ADA CURB RAMP IMPROVEMENTS (PHASE 2)

CONTRACT NO.: 325701

County of Humboldt
 Department of Public Works
 1106 Second Street
 Eureka, CA 95501
 TEL (707) 445-7377
ADDENDUM NO. 1
 (Issued May 19, 2022)

ADA CURB RAMP IMPROVEMENTS PHASE 2
CONTRACT NO.: 325701

INTERSECTION MARKING

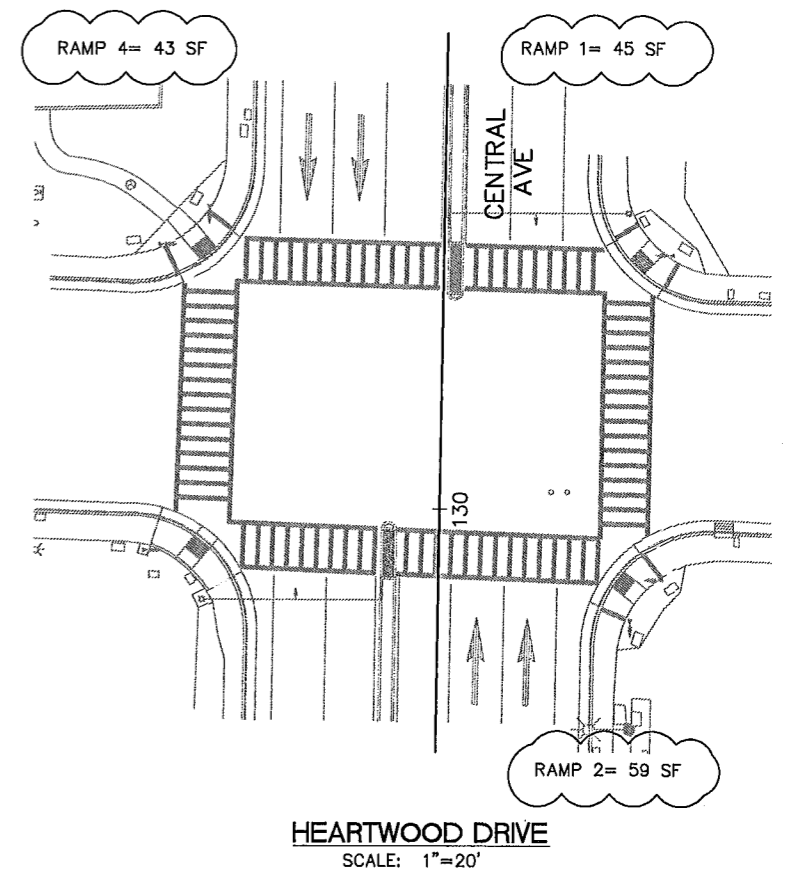
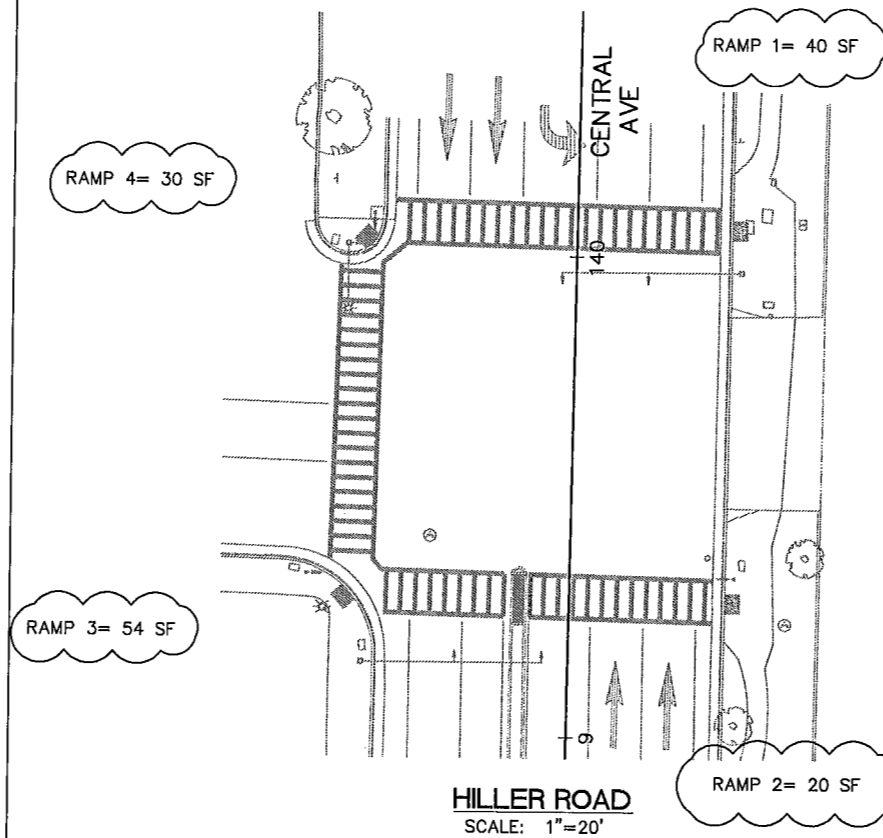
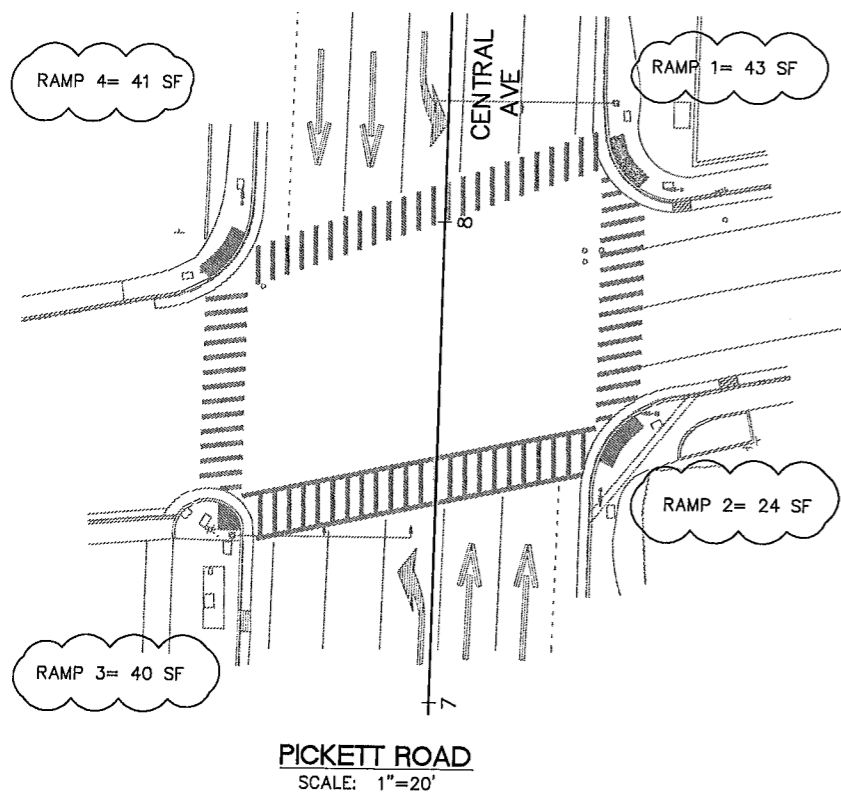
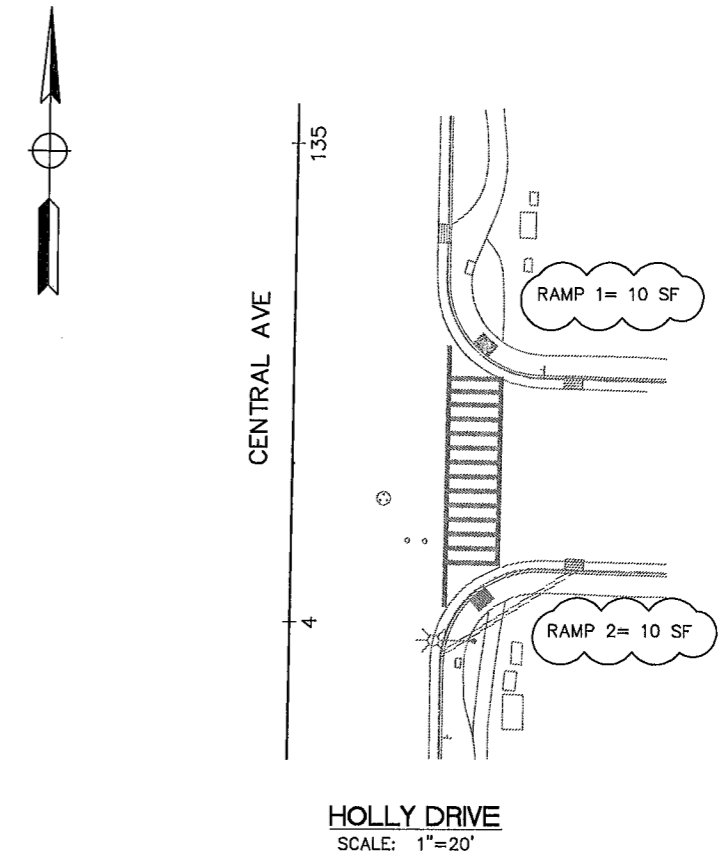
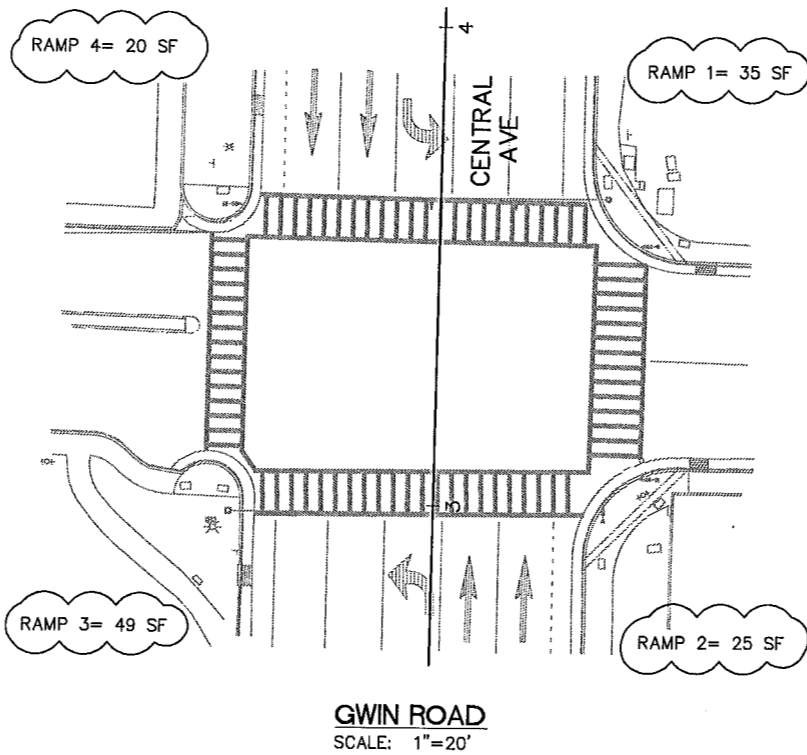
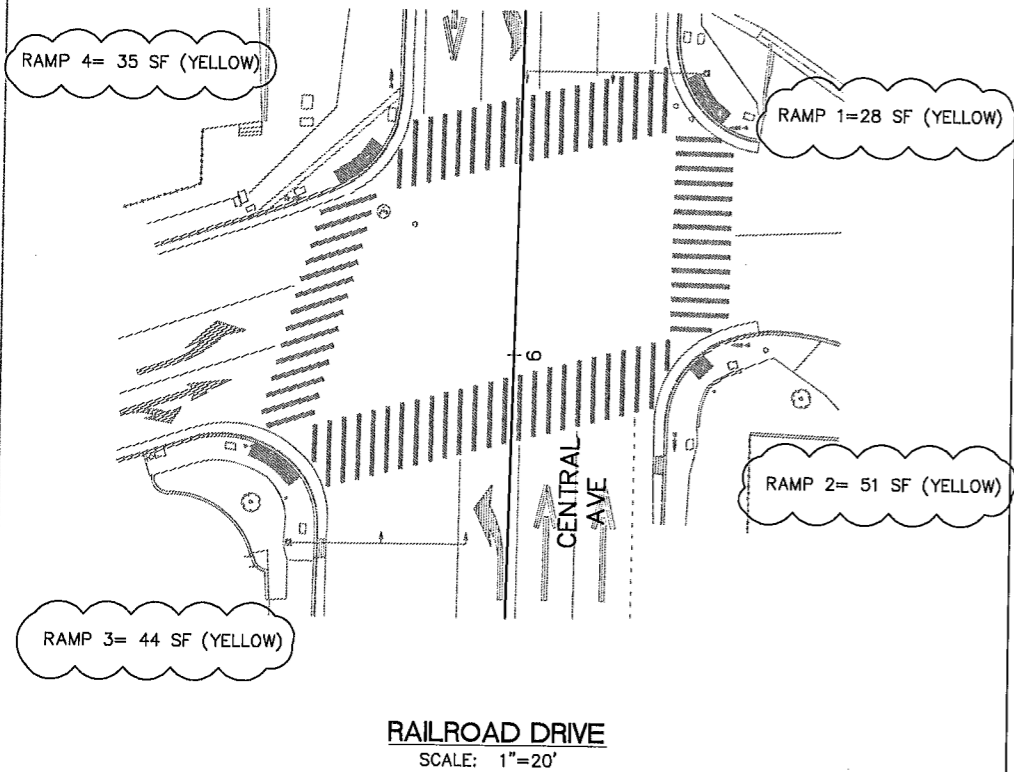
2. Sheets 12, 13, and 15, Quantity Tables, are revised to correct quantities for pavement markings and detectable warning surfaces.
3. Sheets 57-59, Intersection Striping, are revised to correct quantities, clarify the pavement marking work proposed at individual sites, and correct the description of work from "Striping" to "Marking."

2. Confirm the amount of striping to be removed. Plan Sheets 57-59 have the removal amount measured in Lineal Feet; however, removal of pavement markings is usually measured in Square Feet. Note that removal of striping is more expensive than placement of striping. Due to the amount of removal, it may be advisable to add a separate bid item for the removal.

3. Confirm amount of striping to be placed. The amount listed appears low based on the Lineal Feet measurements and crosswalk types shown in the plans.

Revised Plan Sheets 57-59 are attached to correct quantities, clarify the pavement marking work proposed at individual sites, and correct the description of work from "Striping" to "Marking." A separate bid item for removal of thermoplastic pavement marking is included in Addendum No. 1 Bid Form (Exhibit A) to provide for aligning the crosswalk with the new curb ramp at the intersection of Central Avenue and Anna Sparks Way (CR 3-1-60). Pavement markings at all other locations are expected to be removed in the process of constructing the curb ramps.

No pavement striping is anticipated on this project. Revised quantities for Pavement Markings are included in the attached Plan Sheets 12, 13, 15, and 57-59 and Addendum No. 1 Bid Form (Exhibit A).
